**INTERDEPARTMENTAL COMMUNICATION**

**To:** Don Johnson, Town Manager **Date:** July 7, 2006  
**From:** Roland Bart, AICP, Town Planner *R.B.*  
**Subject:** 55 Great Road Site Plan Special Permit, # 06/09/06-407 – McDonald's USA

I have reviewed the 55 Great Road Site Plan Special Permit application for McDonald's USA, LLC, and have the following comments:

# SITE PLAN FOR

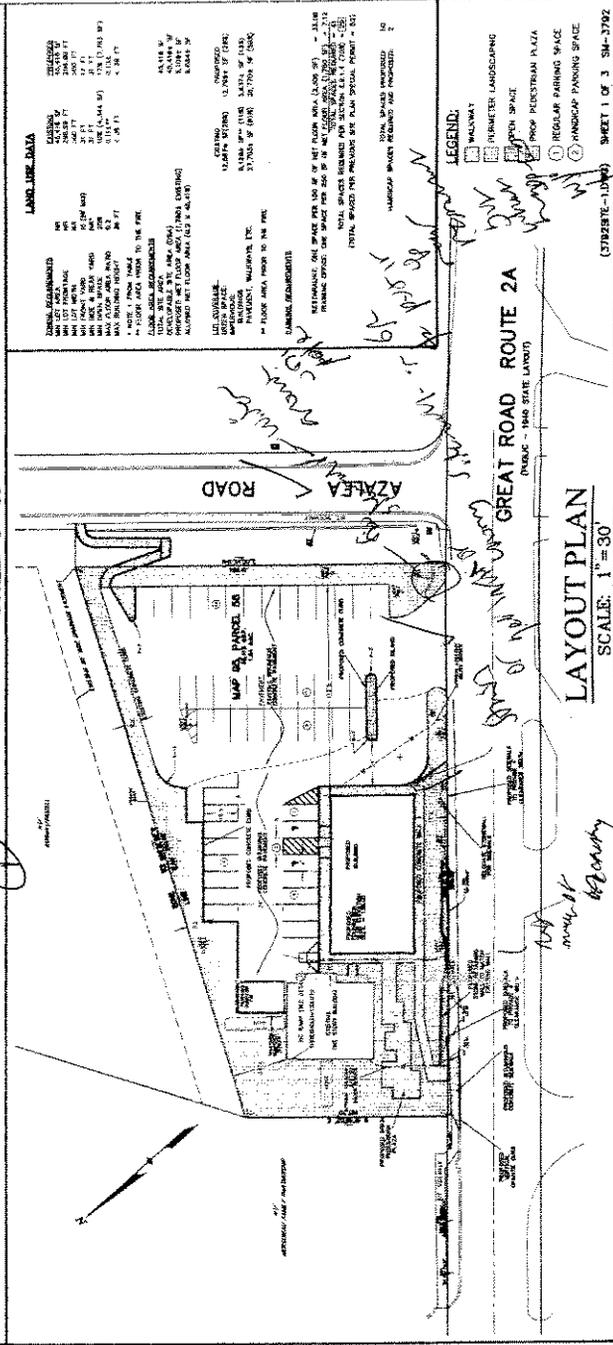
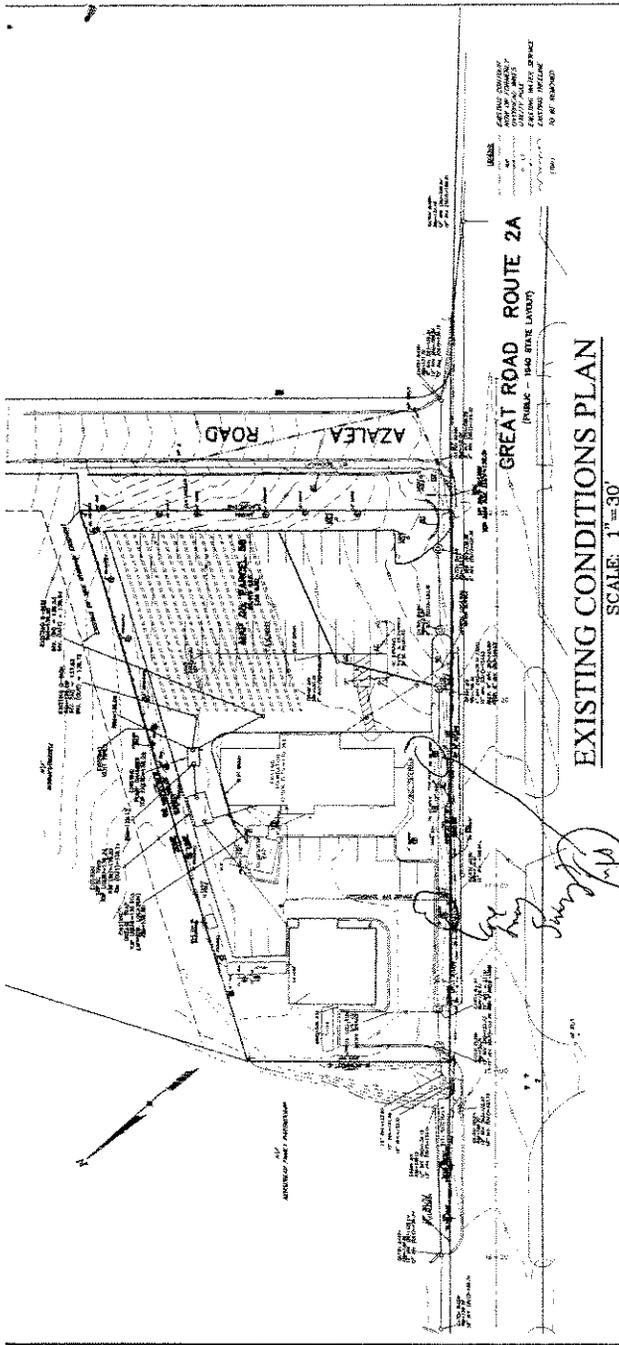
1. People walking west along Great Road will not want to walk past the proposed building to access the walkway to the building 150 feet north of the main entrance, and we do not want to encourage people to walk through the parking lot or across the grass to reach the entrance. For this reason, the applicant should seek a determination from the Architectural Access Board to see whether stairs could be provided between the south side of the proposed building and the Great Road sidewalk and whether the northern sidewalk-to-walkway connection to the building is sufficient to meet accessibility requirements. If the State approves of stairs for a southern sidewalk-to-building connection, stairs should be shown on the plan.

2. People should be able to access the pedestrian plaza more directly from the Great Road sidewalk without having to follow the winding sidewalk leading to the building. The plaza should be designed to open up a little more to people walking along Great Road and encourage them to use it by providing either stairs or a short walkway directly to the plaza where the McDonald's walkway takes a 90 degree turn south to lead up to the building. This additional access point will also make it easier for users to leave the plaza to head west along Great Road.

10. On the Existing Conditions Plan, the zoning district of the abutting properties to the east and south of the site should be changed to R-A (Residence A).

**REAR ELEVATION**  
1/4" = 1'-0"

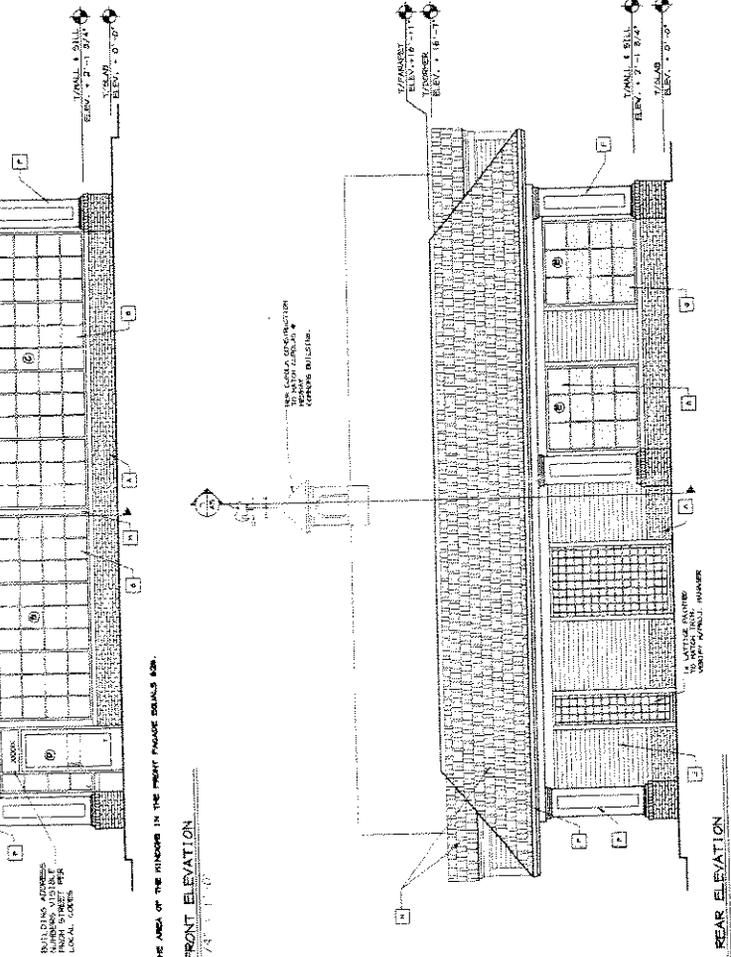
7. Zoning Bylaw section 5.5B.1.2g)vii. states: "The main business entrance to each ground floor business, identified by the larger doors, signs, canopy, or similar means of highlighting, shall be from the building front". Here, this is the side of the building that faces Great Road depicted on the building elevations plan somewhat erroneously as the "left side elevation". The building address numbers should be relocated to above the front door that faces Great Road and the front door should be given the full depth of the roof's eave or overhang that is afforded on other sides of the building.

9. The window lights in the proposed building are oversized and untypical of commercial buildings in historic New England centers. Some are as wide as 2 feet. The lights should be changed to a more uniform reduce width, closer to 1 foot. Giving them a slightly greater vertical dimension would also improve the building's overall vertical presence.
